THE GARDENS AT NORTH CAREFREE CONSTRUCTION DRAWINGS EL PASO COUNTY, STATE OF COLORADO

| GARDENS AT NORTH CAREFREE TITLE SHEET | |

**THE GARDENS AT NORTH CAREFREE
 PLAN AND PROFILE
 STORM SEWER 2 & 3**

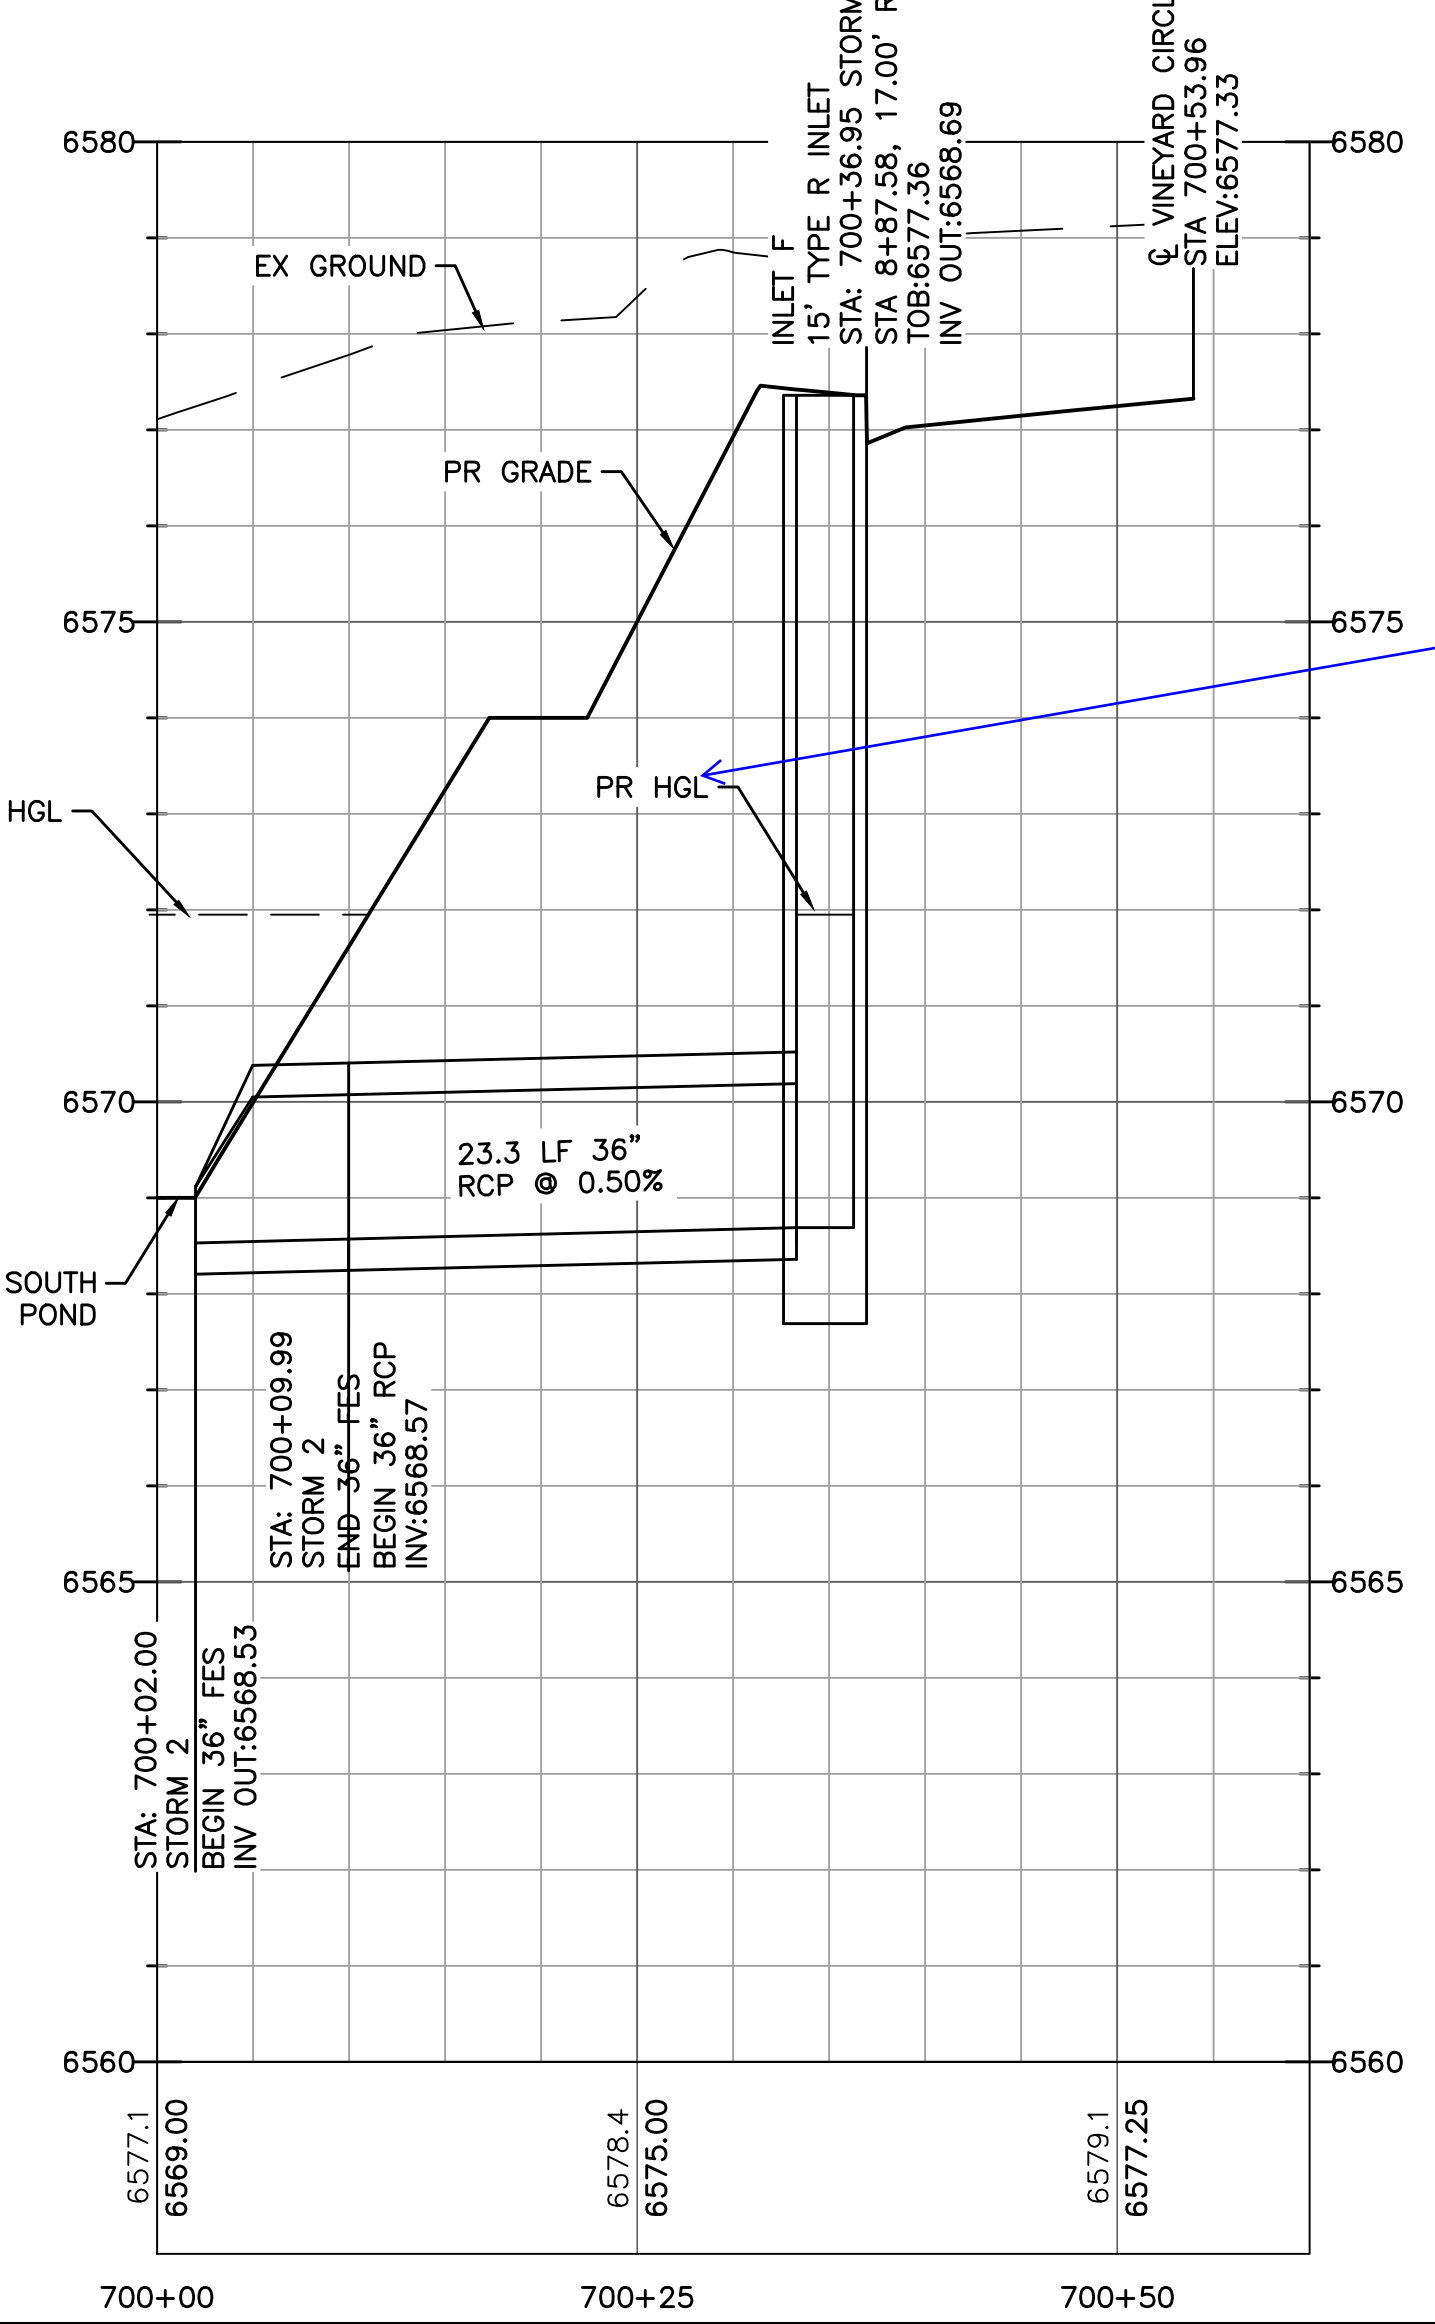
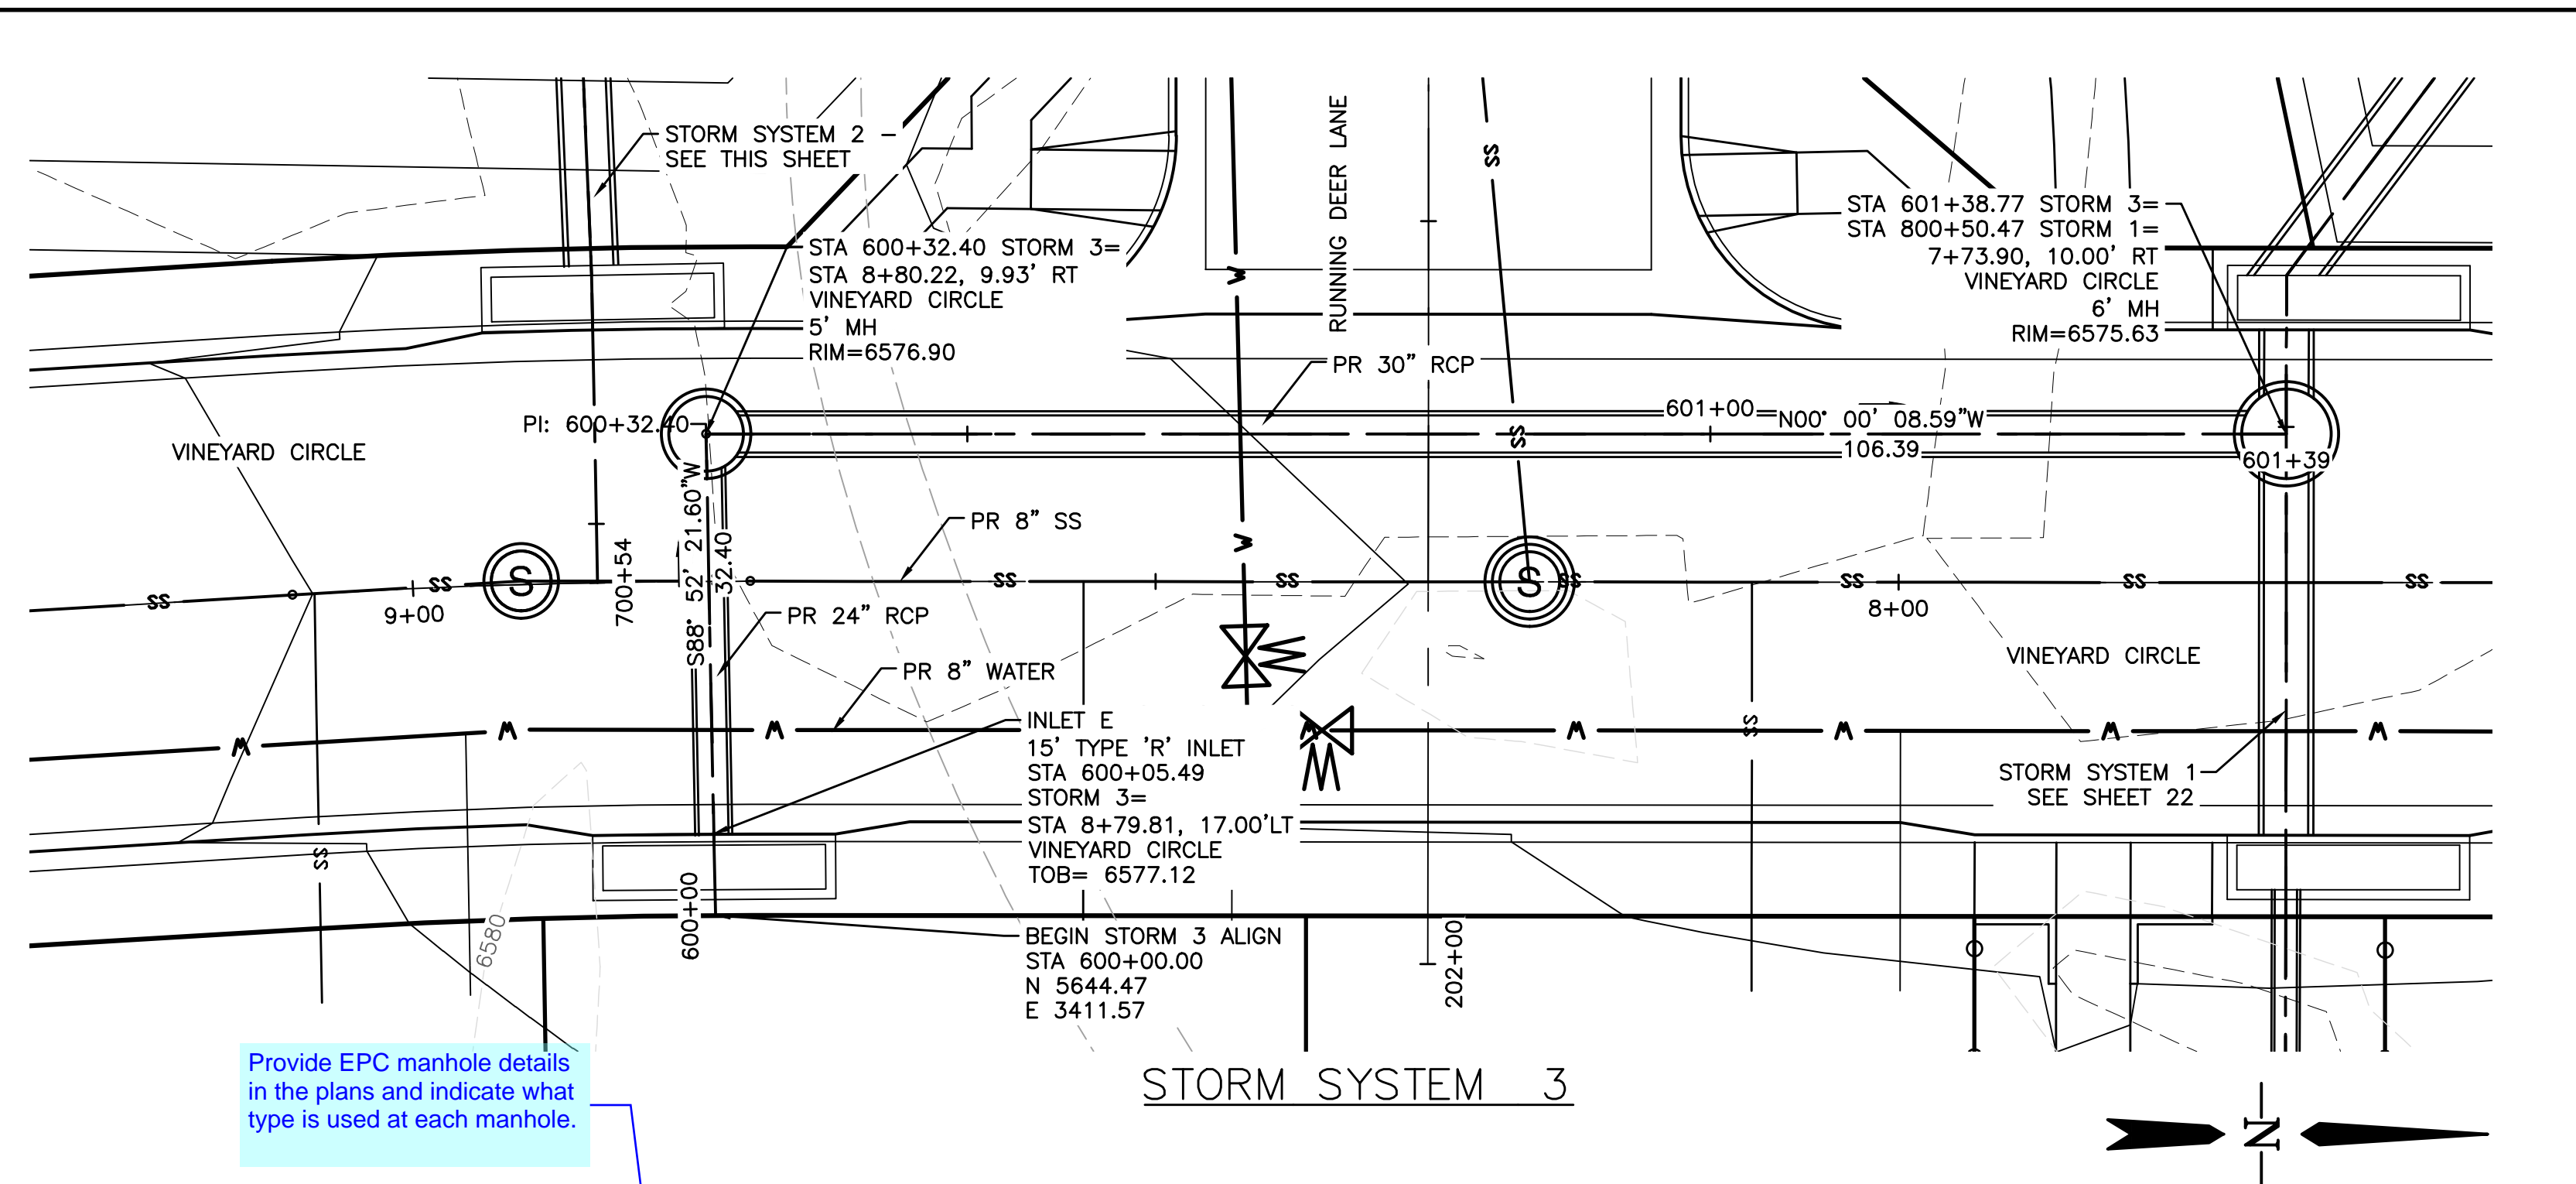
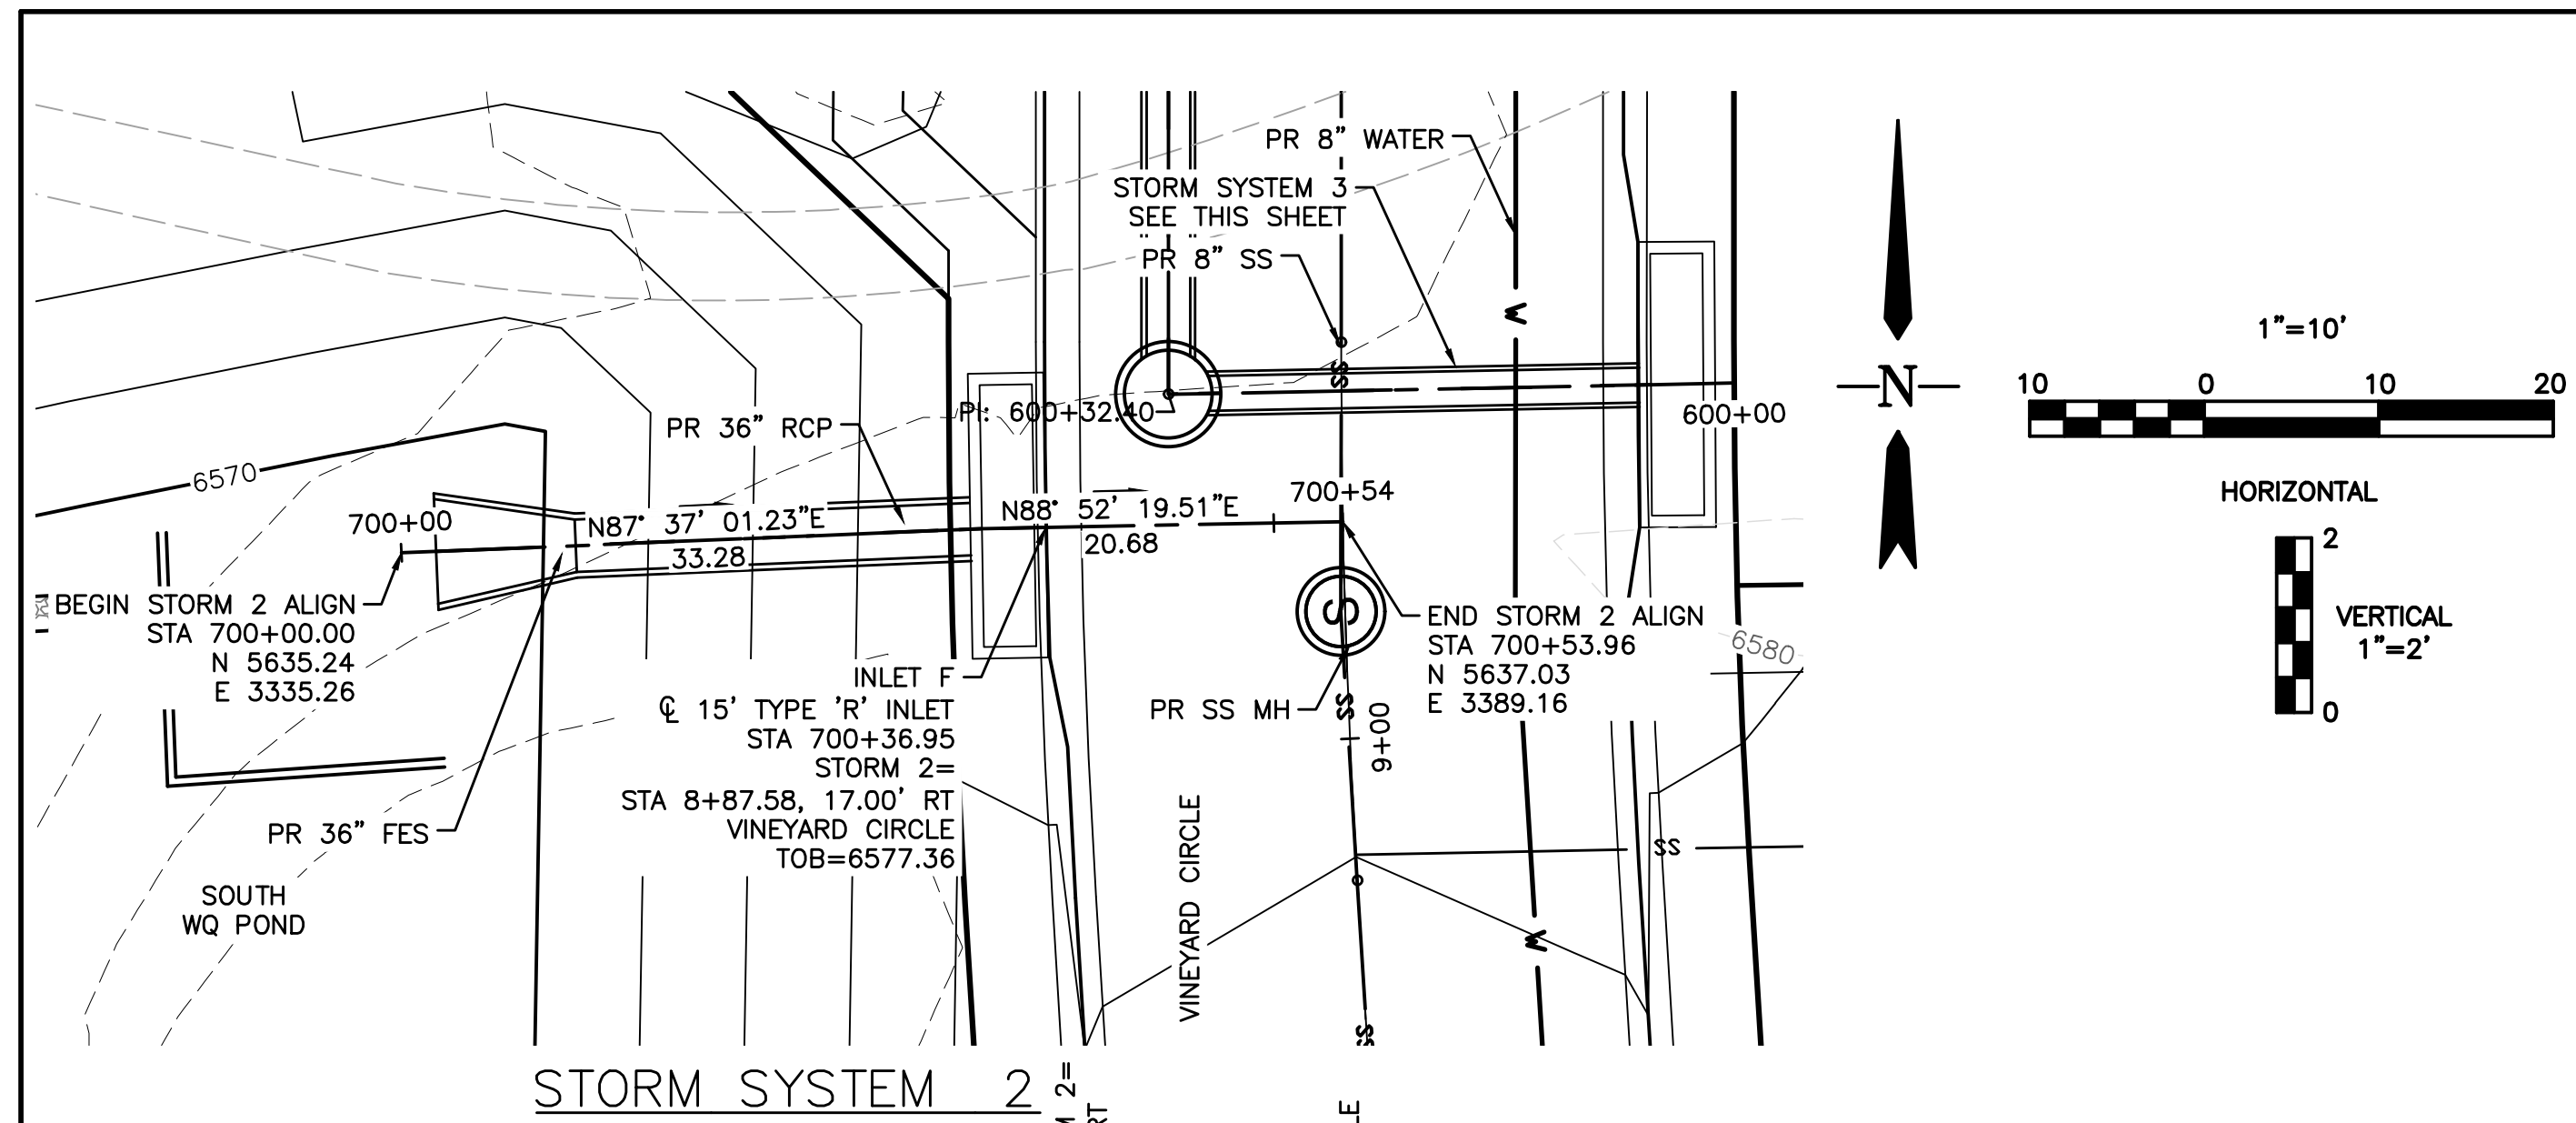
Please indicate this as 100 yr HGL

Provide EPC manhole details in the plans and indicate what type is used at each manhole.
